UNITED STATES PATENT AND TRADEMARK OFFICE

APPLICATION NO.	FILING DATE	FIRST NAMED INVENTOR	ATTORNEY DOCKET NO.	CONFIRMATION NO.
10/571,056	03/07/2006	Francois Le Maner	Q93419	9070
23373 7590 09/02/2008 SUGHRUE MION, PLLC 2100 PENNSYLVANIA AVENUE, N.W. SUITE 800 WASHINGTON, DC 20037				
EXAMINER HAGEDORN, MICHAEL E				
ART UNIT 4159		PAPER NUMBER		
MAIL DATE 09/02/2008		DELIVERY MODE PAPER

Office Action Summary

DETAILED ACTION

Figure 1 – Lina et al (US Patent 5,190,192)

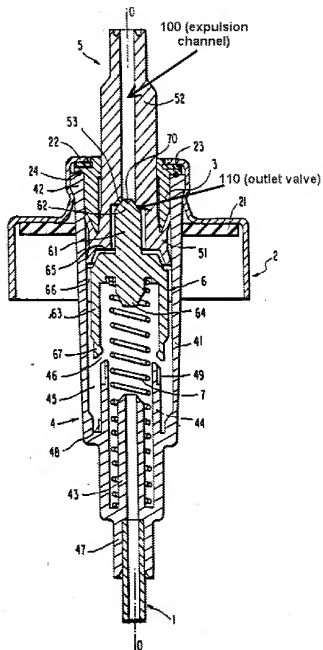
4. In Re claim 1, with reference to figure 1 below, Lina et al discloses A fluid dispenser pump comprising a pump body (4) a pump chamber (45) provided with an inlet valve (46) and with an outlet valve (110), and a piston (5) sliding in said pump body (4) so as to dispense the fluid contained in the pump chamber (45), said outlet valve (110) comprising a valve element (61) co-operating with a valve seat (53) the fluid dispenser pump being characterized in that said outlet valve (110). However, Lina et al fails to disclose an outlet valve comprising a deformable sealing means provided

5. In re claim 2, with reference to figure 1 above, Lina et al discloses a pump, in which said piston (5) is secured to an actuator rod (52), said actuator rod being hollow and defining an expulsion channel (100) for the fluid, said valve seat (53) being formed in said expulsion channel (100).
6. In re claim 3, with reference to figure 1 above, Lina et al discloses a pump in which, while the pump is being actuated, the outlet valve (4) is urged towards its closed position by a spring (7), said valve (110) being opened by the pressure of the fluid contained in the pump chamber (45).

10. In re claim 7, Lima discloses a frustoconical surface (62). This surface would cooperate with the deformable annular lip of claim 6, when in the closed position (fig. 1 of Lima).

14. In re claim 15, with reference to figure 1 below, Lina discloses a fluid dispenser device, characterized in that it includes a pump (4).

Figure 3a – Crosnier et al (US Patent 6,932,246)

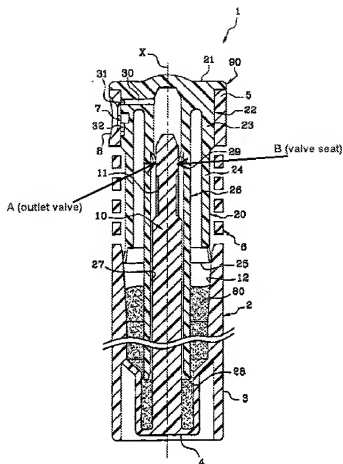
between said valve seat and said valve element, said sealing means being elastically deformed when said outlet valve is in the closed position, so as to improve sealing. Crosnier et al, with reference to figure 3a below, does disclose an outlet valve (A) further comprising a deformable sealing means (29) provided between said valve seat (B) and said valve element (10), said sealing means (29) being elastically deformed (Column 3, lines 63-66) when said outlet valve (A) is in the closed position, so as to improve sealing. It would have been obvious to one of ordinary skill in the art to implement Crosnier's teaching into Lina's because as stated in the claim would these teachings will improve the sealing between the outlet valve and valve element.

7. In re claim 4, Crosnier et al, with reference to figure 3a above discloses a pump in which said deformable sealing means (Column 3, lines 63-66) is formed on the valve seat (B). However, it would have been obvious to one having ordinary skill in the art at the time the invention was made to have a pump in which said deformable sealing means is formed on the valve element, since it has been held that a mere reversal of essential working parts of a device involves only routine skill in the art. In re Einstein, 8 USPQ 167. Please note that in the instant application, applicant has not disclosed any criticality for the claimed limitations.

8. In re claim 5, Crosnier et al, with reference to figure 3a above, discloses a pump in which said deformable sealing means (Column 3, lines 63-66) is formed on the valve seat (B).

9. In re claim 6, the sealing means of Crosnier et al, with reference to figure 3a above comprises at least one deformable annular lip (29).

11. In re claim 8, Crosnier et al, with reference to figure 3a, above, discloses that said annular lip (29) is made by molding (column 7, lines 34-37). In accordance to MPEP 2113, the method of forming the device is not germane to the issue of patentability of the device itself. Therefore, this limitation has not been given patentable weight. Please note that even though product-by-process claims are limited by the defined by the process, determination of patentability is based on the product itself. The

12. In re claim 9, Crosnier et al, with reference to figure 3a above, discloses a pump, in which the valve seat (B) includes a flexible annular lip (29) co-operating with a frustoconical valve element (10), said valve element (10) being substantially rigid.

13. In re claim 10, Crosnier et al, with reference to figure 3a below, discloses a pump, in which the valve seat (B) is made out of two materials, said annular lip (29) being made out of a material that is softer than the remainder of the valve seat (B).

Figure 4 – Roger (US Patent 4,420,011)

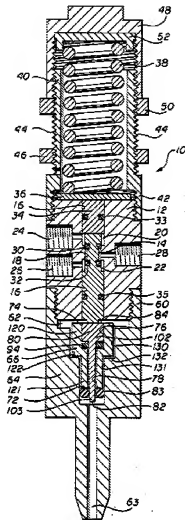
16. In re claim 11, Lina has been discussed above, but doesn't disclose a pump in which said deformable sealing means comprises a deformable O-ring. However Roger, with reference to figure 4 below, discloses a pump in which said deformable sealing means comprises a deformable O-ring (83). The claim would have been obvious because the substitution of one known element for another would have yielded predictable results to one of ordinary skill in the art at the time of the invention.

17. In re claim 12, Roger with reference to figure 4 above said O-ring (83) co-operates with a frustoconical surface when the valve (103) is in the closed position. This surface would cooperate with the O-ring of claim 11, when in the closed position (Fig 1 of Lima).

18. In re claim 13, Roger, with reference to figure 4 above discloses said O-ring (83), secured by interfitting, snap-fastening, or overmolding. In accordance to MPEP 2113,

19. In re claim 14, Roger with reference to figure 4 above discloses the valve element (103) is substantially rigid and includes a deformable O-ring (83) co-operating with a fustoconical valve seat (82), said valve seat (82) being substantially rigid.
